SERVICE BULLETIN

N° 189-278

ATA 21 - ECS ELECTRIC LINES CLIPPING MODIFICATION

Figure 1

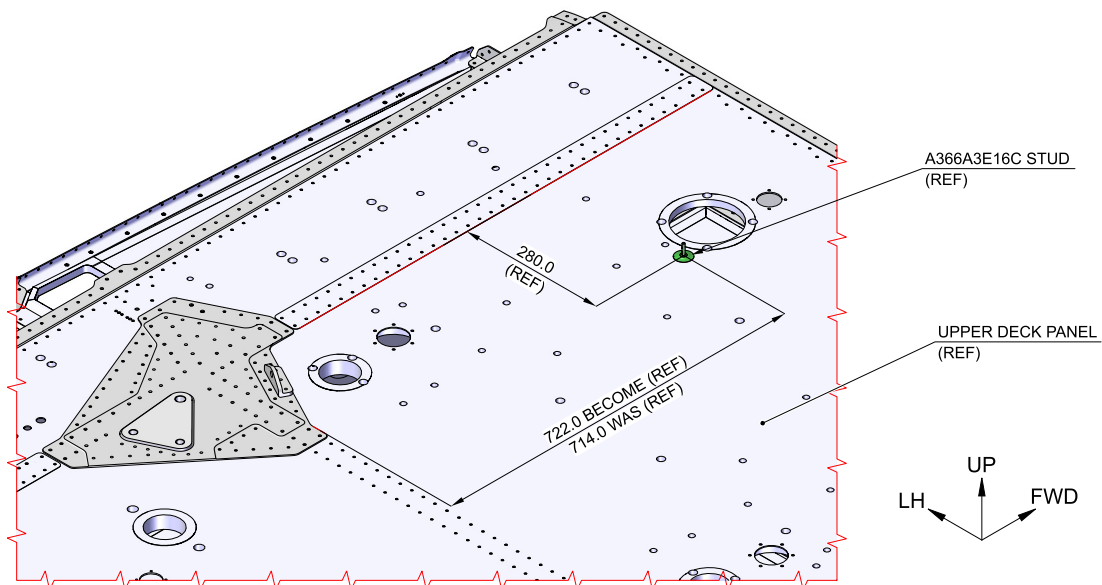
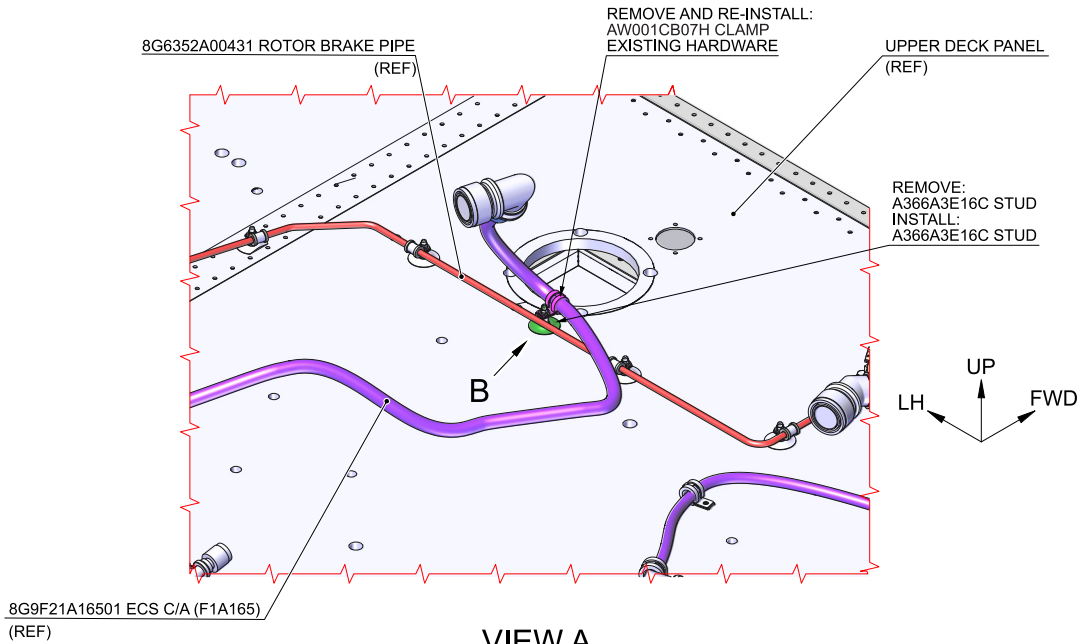
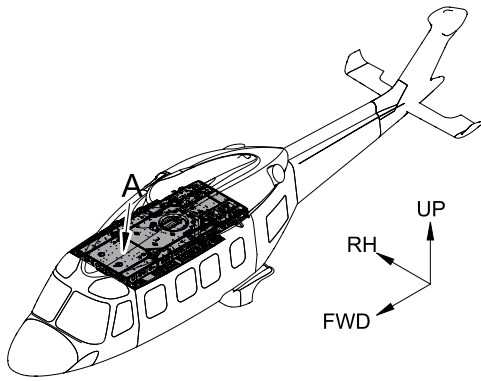
Leonardo Helicopters identified a possible interference on the upper deck between the rotor brake hydraulic line and a stud which is part of the ECS kit electrical harness clipping.

This Service Bulletin gives instructions on how to change the ECS cable path, repositioning the stud in a new position and avoid any possibility of interference with the rotor brake pipe assy P/N 8G6352A00431.

2. In accordance with AMP DM 89-A-06-41-00-00A-010A-A and with reference to Figure 1, open the sliding cowling 451A and get access to the area affected to perform the repositioning of the stud P/N A366A3E16C:

- 2.1 With reference to Figure 1 View A, remove and retain the clamp P/N AW001CB07H and its fixing hardware from the existing stud P/N A366A3E16C.
 - 2.2 In accordance with the applicable steps of AMP DM 89-A-20-10-16-02A-920A-A and with reference to Figure 1 View A, remove the stud P/N A366A3E16C from the upper deck panel.

- 2.3 In accordance with the applicable steps of AMP DM 89-A-20-10-16-02A-920A-A and with reference to Figure 1 View A and View B, install the stud P/N A366A3E16C in the new position on the upper deck panel in accordance with the dimensions shown.

- 2.4 With reference to Figure 1 View A, re-install the clamp P/N AW001CB07H previously removed on the stud P/N A366A3E16C by means of the existing hardware.
